## **SERVICE BULLETIN**

### **SERVICE BULLETIN INDEX**

FIGURE 1

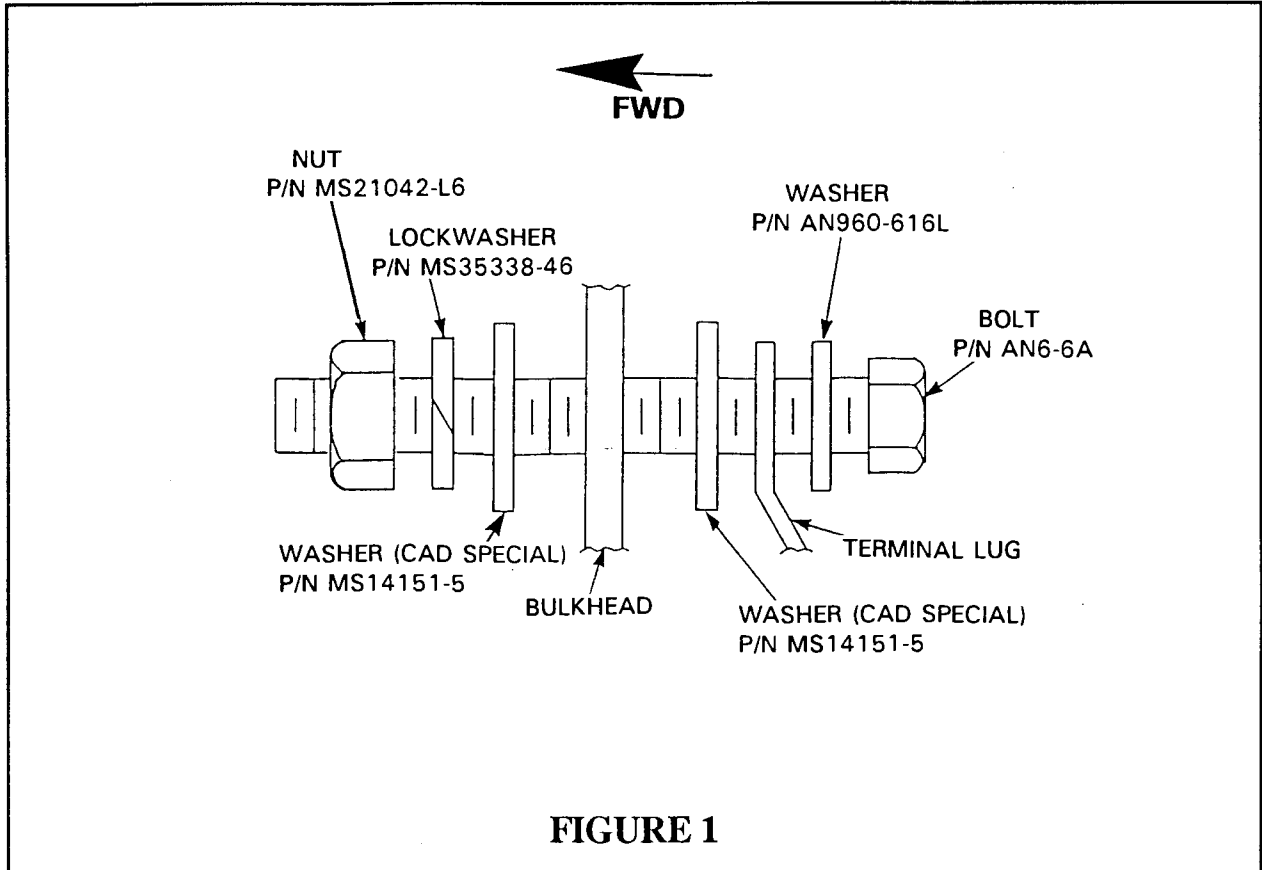
- H. Assemble grounds using new hardware. Head of bolt on aft side of extrusion. Refer to Figure 1.

FIGURE 2

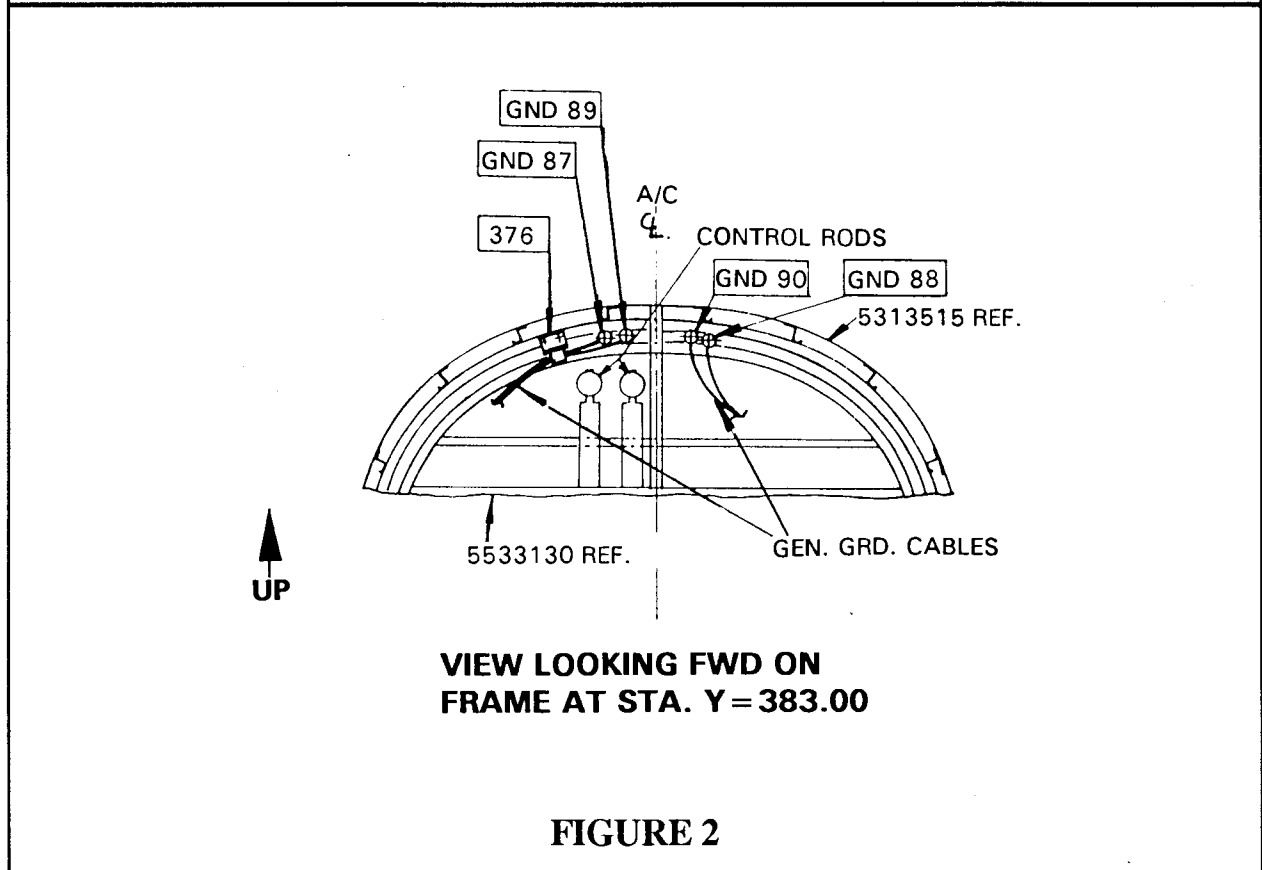
- (1) 38 GND - #2 battery ground return (Sta. 340 RHS)
  - (2) 39 GND - #1 battery ground return (Sta. 340 LHS)
  - (3) 87 GND, 88 GND, 89 GND and 90 GND - #1 and #2 generator ground returns (Sta. 383 overhead, left and right of aircraft centerline) on aft wall of forward baggage compartment. Refer to Figure 2.

**FIGURE 3**

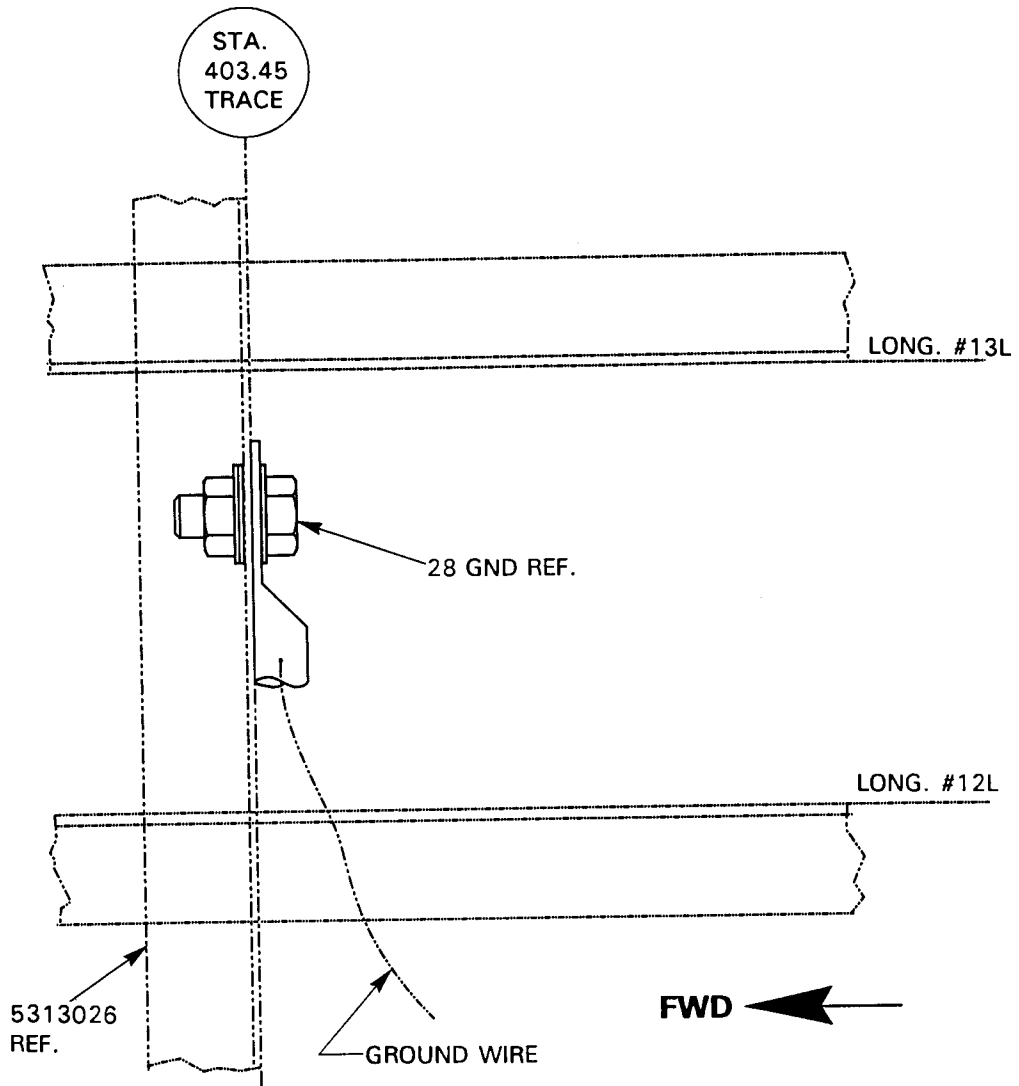
- E. For 28 GND only; enlarge hole in structure (Frame 403.45) and in terminal lug 28 GND to 0.385-.400 inches if required. Refer to Figure 3
- F. Remove all paint and primer from both sides of all terminal lugs and mating area structure.

FIGURE 1

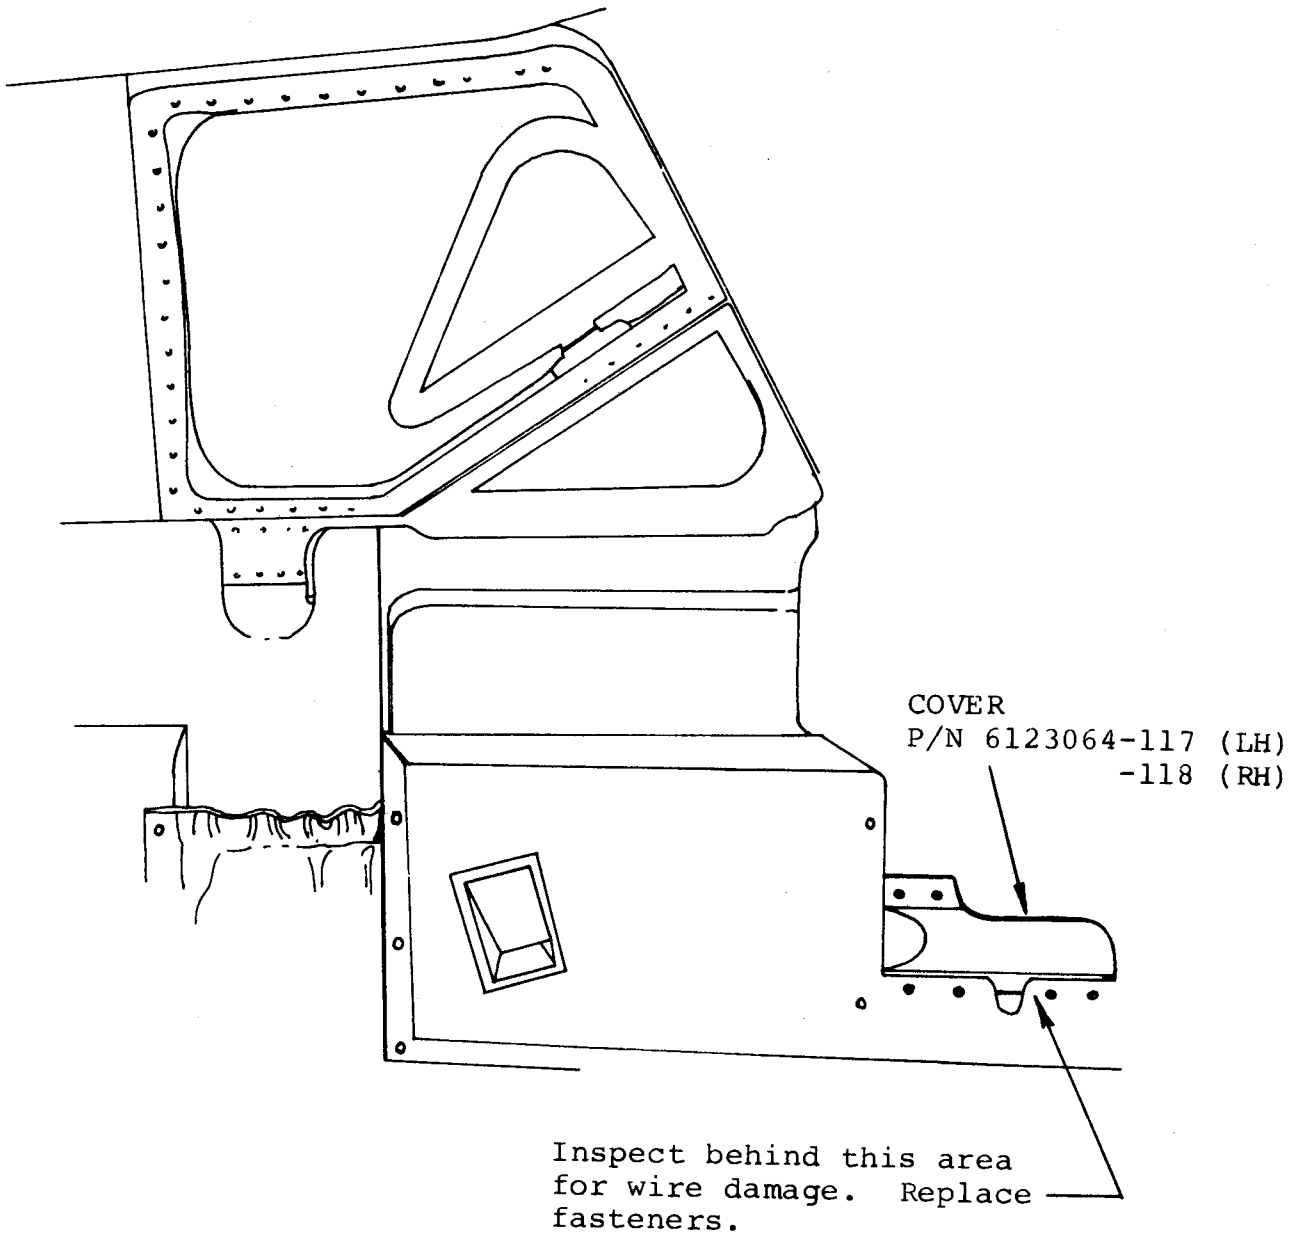
- A. Turn off battery and electrical master switches and assure that external power is not applied to the aircraft.
- B. Remove the lower forward left and right hand panels. See Figure 1.
- C. Inspect the cable bundles in the area immediately behind the lower forward mounting screw on both LH and RH covers for wire damage. Should damage or chafing be noted, repair wires as necessary.

- D. To prevent further damage, wrap the affected area with PVC-80 or equivalent chafe-guard and secure with tie-wraps.
- E. Remove the existing tinnerman type nut-plates from the lower forward positions on each cover and replace them with new nut-plates NAS1474A08. The new nut-plates may be located and riveted in place with MS20426AD3-4 rivets.
- F. Reinstall the left and right covers using washer NAS391-8P and screw MS24693-S48.

FIGURE 1

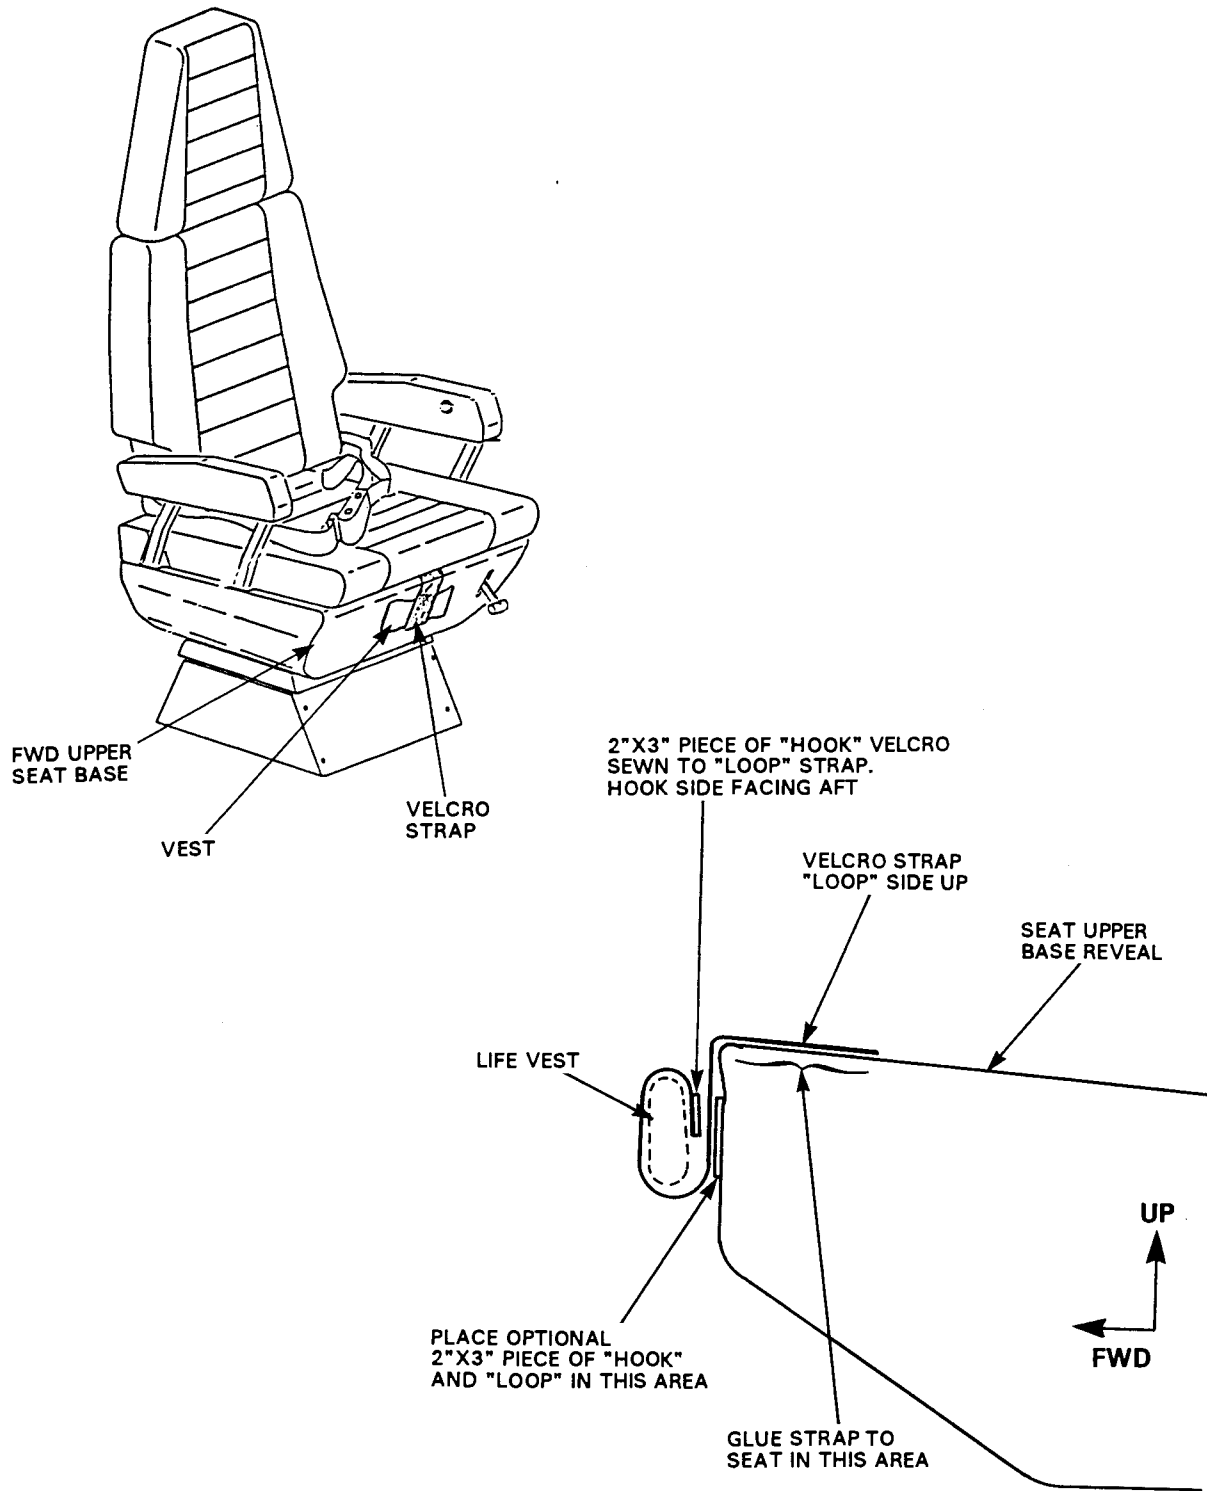
- E. Place life vest with strap assembly in front of seat cushion upper base and allow life vest to hang from velcro strap. Refer to Figure 1.
- F. When desired location is achieved, cut velcro "Loop" strap to appropriate length.

- G. Secure backing side of "Loop" strap to seat cushion support with 3M Scotch Grip P/N 3M 1300L. Refer to Figure 1.
- H. Perform same installation sequence with remaining cabin seats.

FIGURE 1

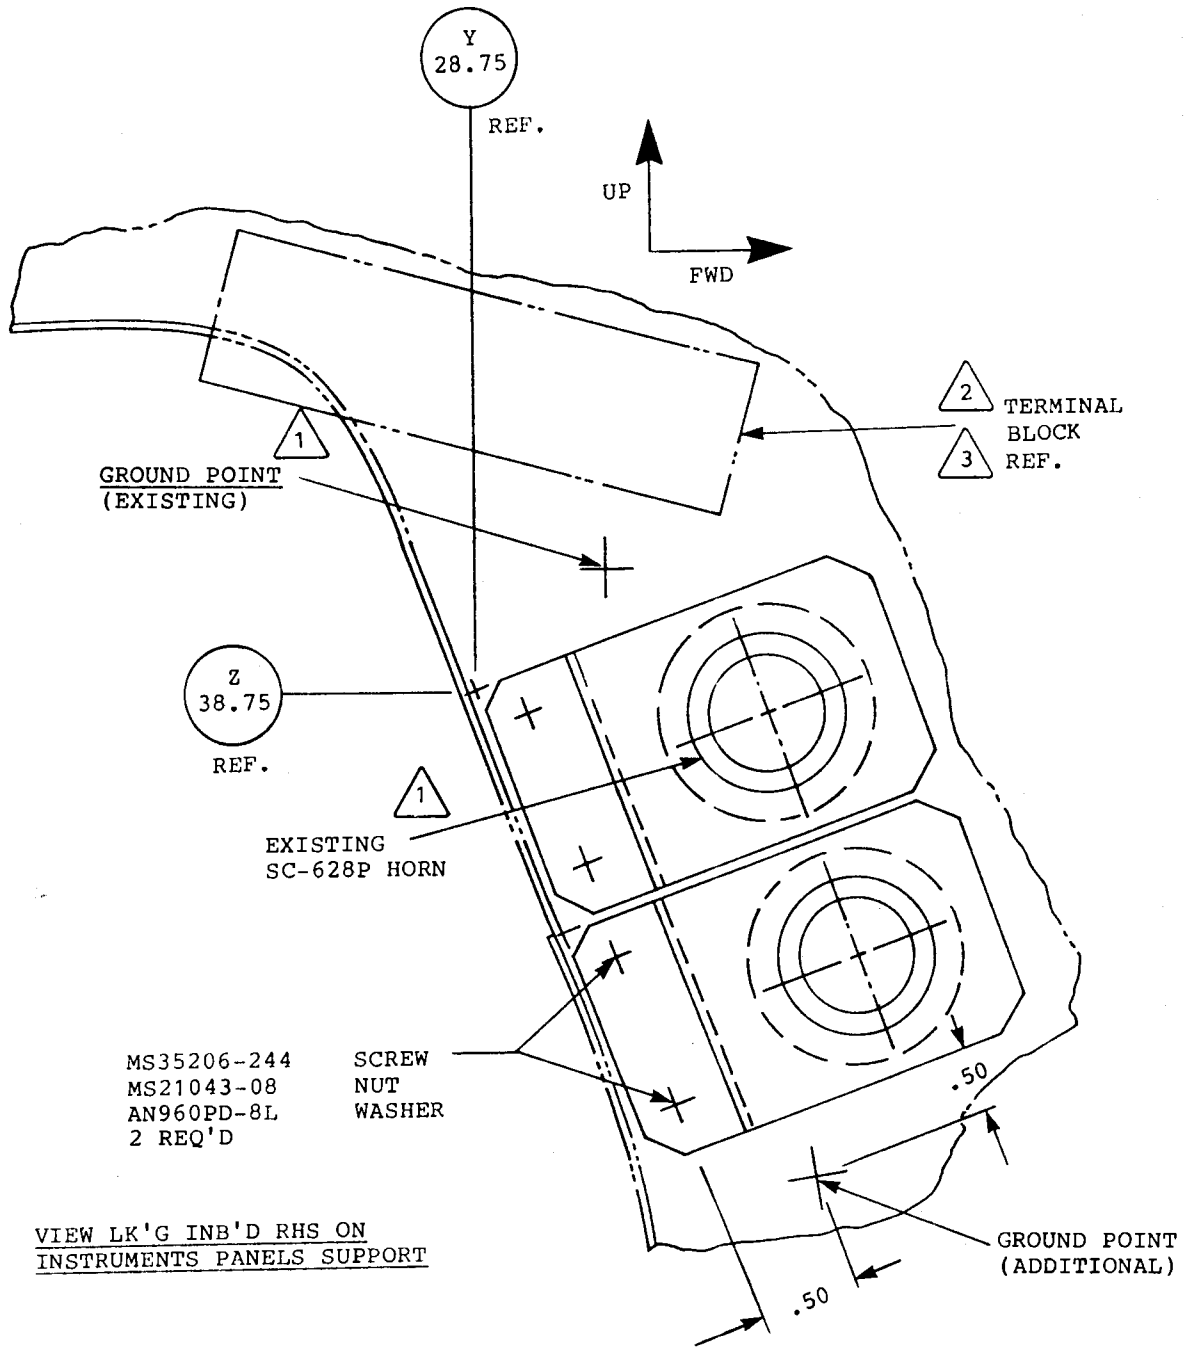
- (8) Locate terminal board on outboard side of right hand instrument panel support assembly. (Reference Figure 1 for location.)
- (9) Locate plugs J49 and J18 on shelf aft of forward pressure bulkhead.

- (1) Locate and mount two (2) Zee brackets (P/N 101-722-50-56) on the center instrument panel support assembly (copilot side). Reference Figure 1 for location and mounting.

FIGURE 2

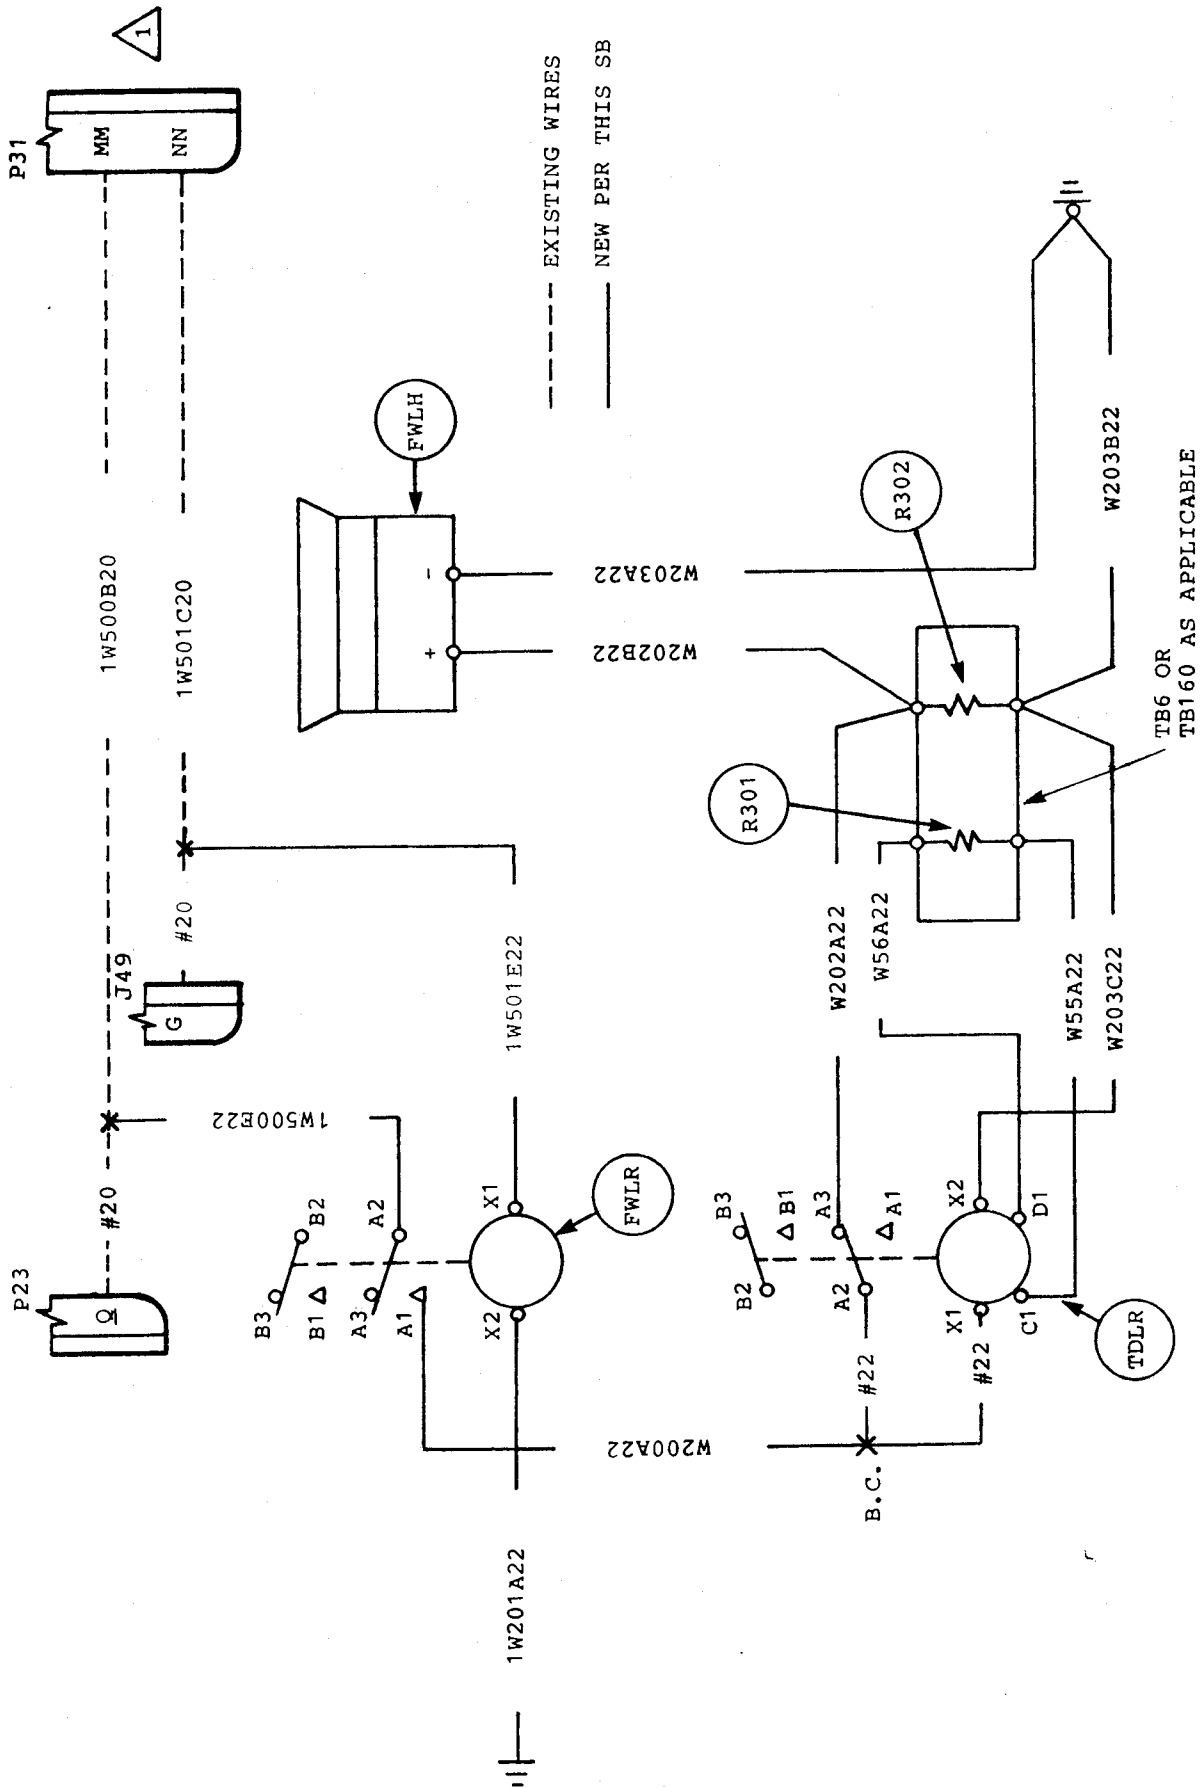
- (1) Complete all wiring as per Figures 2 and 3 (LHS and RHS, respectively), using standard shop practices.
  - (a) Plugs J49 and J18 are located on shelf aft of forward pressure bulkhead.
  - (b) Plugs P23 and P24 are located in the overhead panel (LHS and RHS, respectively).
  - (c) The terminal block is located and identified as per Figure 1 on the instrument panel support.
